CULTURAL HERITAGE IMPACT STATEMENT

100 Argyle Avenue, Ottawa ON

Revision #4

Re: 100 Argyle, Heritage & Urban Design Comments October 2020.

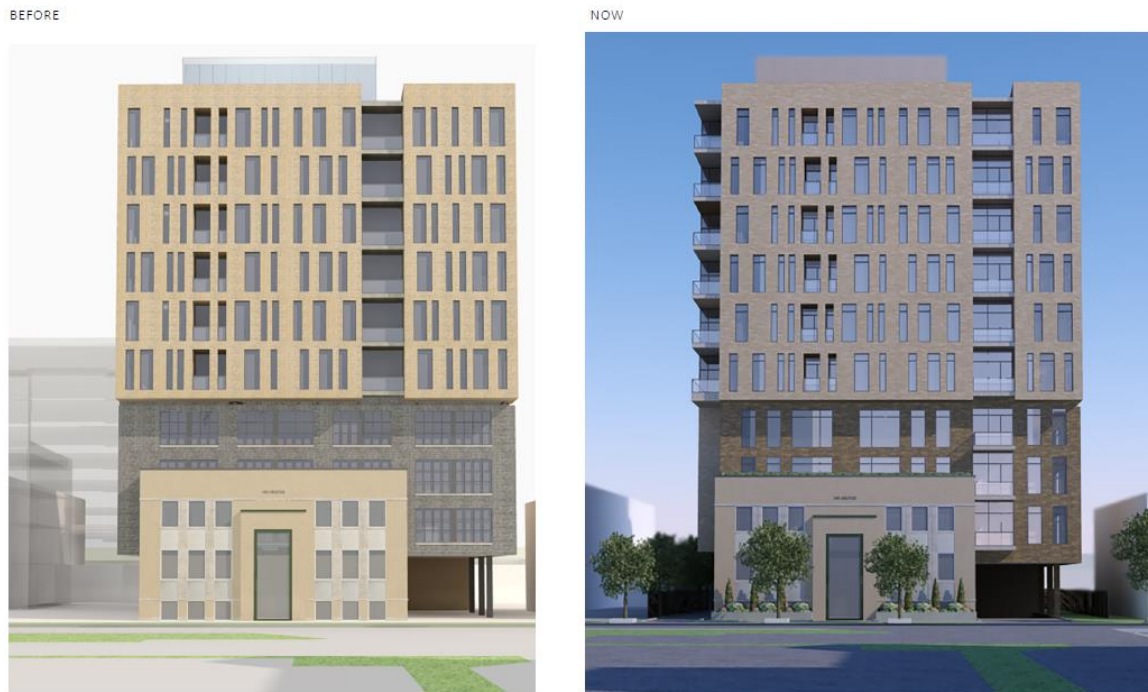
- *The building reads as three very separate pieces; staff would suggest that the distinction between the pieces could be more subtle, for example instead of black brick maybe a contextual colour? (i.e. look to surrounding buildings in Centretown) to improve compatibility.*

- *Similarly, the overall compatibility of the infill with the historic building could be improved. How does the top portion, beyond colour and material, relate to the historic portion of the building? I would suggest looking for opportunities to improve this connection through the fenestration pattern to more clearly connect it to the historic portion of the building. This could be achieved through a more regular window placement or the alignment of windows on the infill with the historic portion of the building. You may also wish to look to other surrounding buildings for elements to draw from for an improved relationship to the HCD.*

RLA Response – We have changed the tone of the dark grey brick of the ‘belt’ zone to a darker brown brick which is similar to the dark toned brick used at The Windsor Arms (150 Argyle) to the West.

RLA Response – We have relocated the vertical slot balconies in the upper ‘box’ and removed a portion of the upper box at the north east corner. This establishes an alignment of the heritage façade and the volume above. We have also revisited the glazing pattern directly above the heritage facade in the ‘belt’ zone. The glazing in this area now has an expressed ‘local symmetry’ so it acts as a mediator between the symmetrical heritage façade and the more dynamic upper façade of the ‘box’.

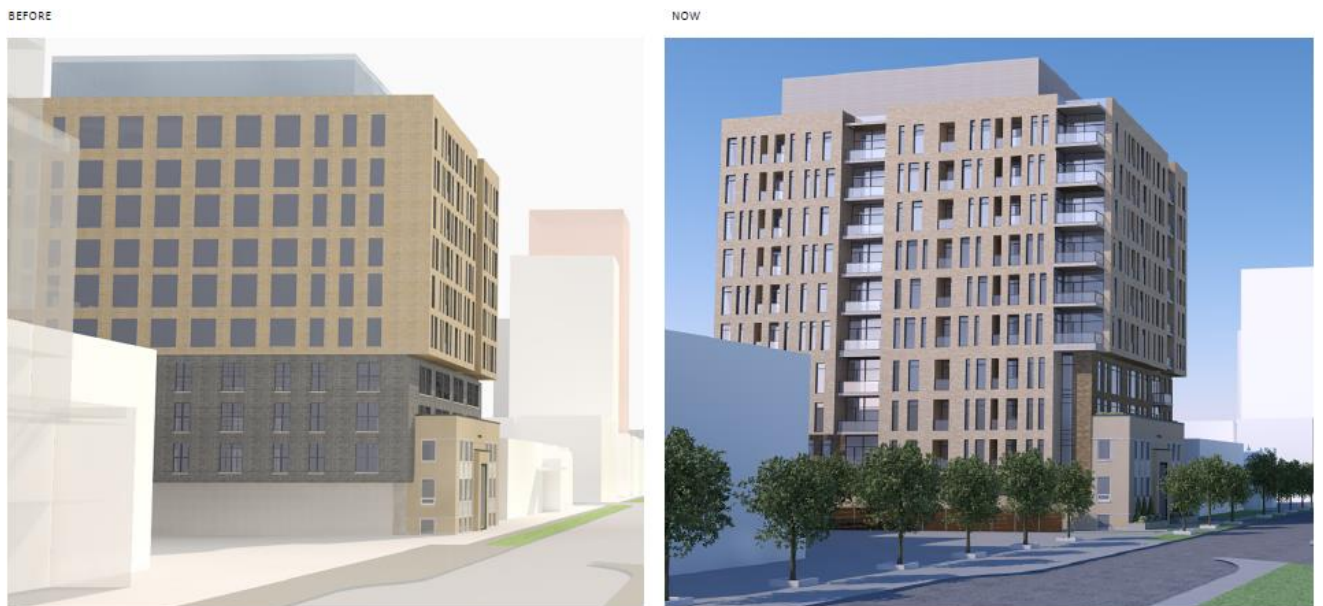
- *The Box: We appreciate and support the efforts made to have this portion of the design relate to but stand apart from the heritage portion of the building and find it relatively successful, however, we do suggest that there are further ways to relate 'the box' to the heritage portion through additional design alignments. We believe that having elements of the heritage building that form real or implied lines and relationships can be drawn graphically into the facade organization of 'the box'. A couple of obvious examples are the vertical lines created on the heritage building through the alignment of windows stacked above each other. Although 'the box' has positioned itself in diametric opposition to this by refusing the vertical alignment of its windows it could provide a vertical relief or as seen through the inset balconies.*

RLA Response – We have relocated the vertical slot balconies on North elevation of the upper 'box' more to the West, and removed a portion of the upper box at the northeast corner. This establishes an alignment of the heritage façade and the volume above. We have also revisited the glazing pattern directly above the heritage facade in the 'belt' zone. The glazing in this area now has an expressed 'local symmetry' so it acts as a mediator between the symmetrical heritage façade and the more dynamic upper façade of the 'box'. We have lastly pulled down a section of the 'box' along the east façade, which accomplishes two things – it now loosens the static divisions between the three distinct zones, and it allows the 'box' to frame the heritage form from the easterly vantage points along Argyle Street.
